**Report: TAB REPORT  
Function: Test, Adjust, & Balance  
Date: 06/26/2023**

**PROJECT  
06-19-23 CULVERS - COLUMBUS, GA**

## Issue List

HVAC PLAN

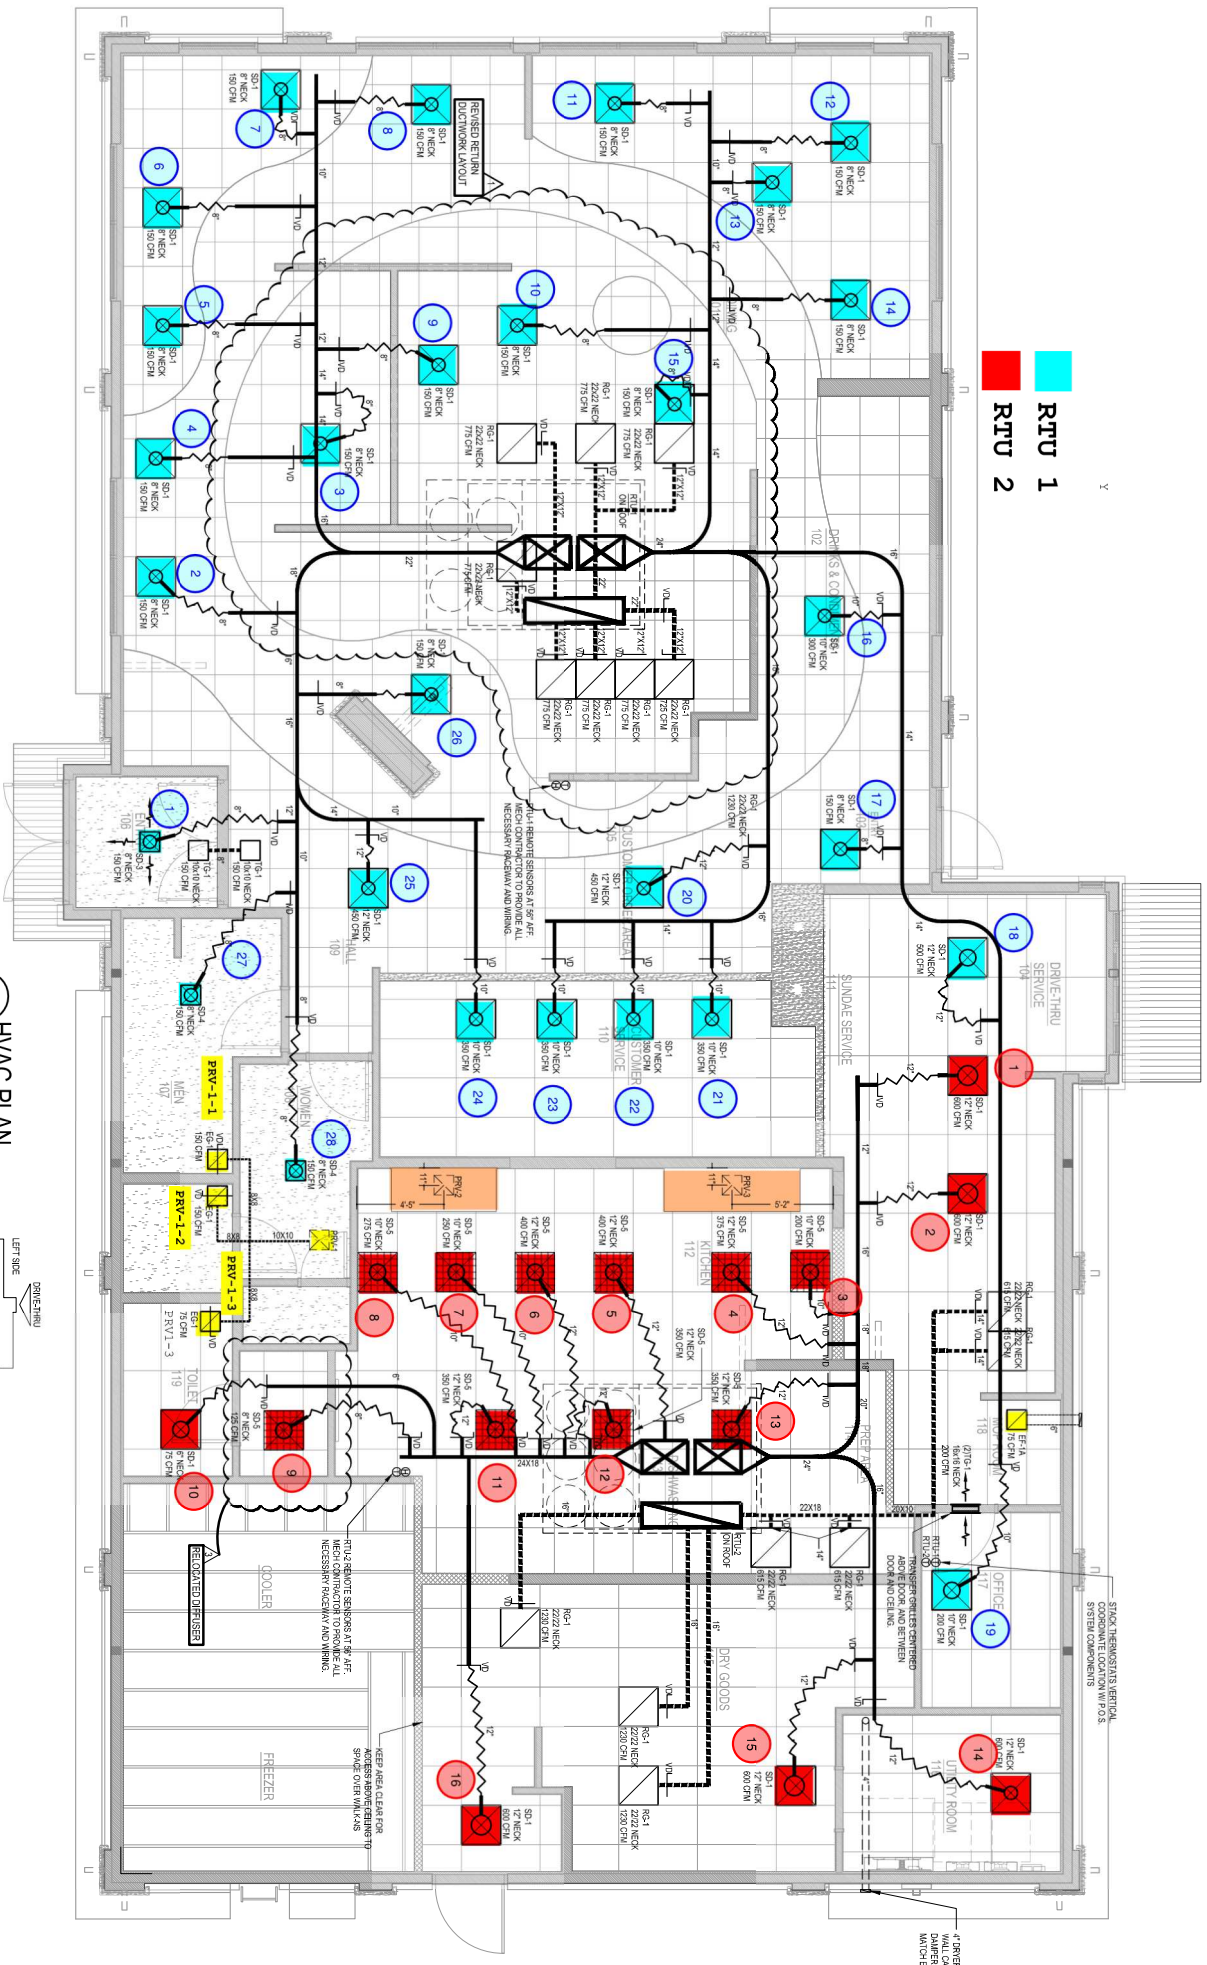
**Issue Name :** Office Diffuser Ductwork  
**Description :** Office supply diffuser is ducted to rtu2 instead of rtu1. MSET M101 calls for that diffuser to be ducted to rtu1. Per the MC the truss work makes ducting to rtu1 impossible. This may lead to uncomfortable temperatures in the office as the kitchen has a different demand for heat/cool than the office.  
**Created By :** National TAB                      **Assigned To :** National TAB - William Patton  
**Status :** Open  
**Originated Date :** 06/21/2023 - William Patton - National TAB

**Issue Name :** RTU 1 Low Diffusers  
**Description :** As a result of incorrect dampers being installed and the ductwork layout differing from that shown on the MSET there are 4 diffusers that are below design. Several full passes were made to attempt to resolve this but were unsuccessful. Space is comfortable as is.  
**Created By :** National TAB                      **Assigned To :** National TAB - William Patton  
**Status :** Open  
**Originated Date :** 06/21/2023 - William Patton - National TAB

**Issue Name :** RTU 2 Diffuser 15 Low Flow  
**Description :** Diffuser 15 (dry goods) is 351/600cfm. After several full passes, total increase in flow to this diffuser was 63 cfm, with all other diffusers falling within design. After inspection technician could not diagnose what is causing restriction. Recommend mechanical contractor investigates ductwork and volume damper for any issues.

- **06/22/2023 National TAB - William Patton**
  - RECOMMENDED TO INSTALL VOLUME DAMPERS FOR THE DIFFUSERS AT THE TAKEOFFS. IT IS ALSO RECOMMENDED TO INSTALL BRANCH DAMPERS. NTAB WAS UNABLE TO SEE OR USE ANY BRANCH DAMPERS DUE TO SPRAY INSULATION ON THE DUCTWORK.
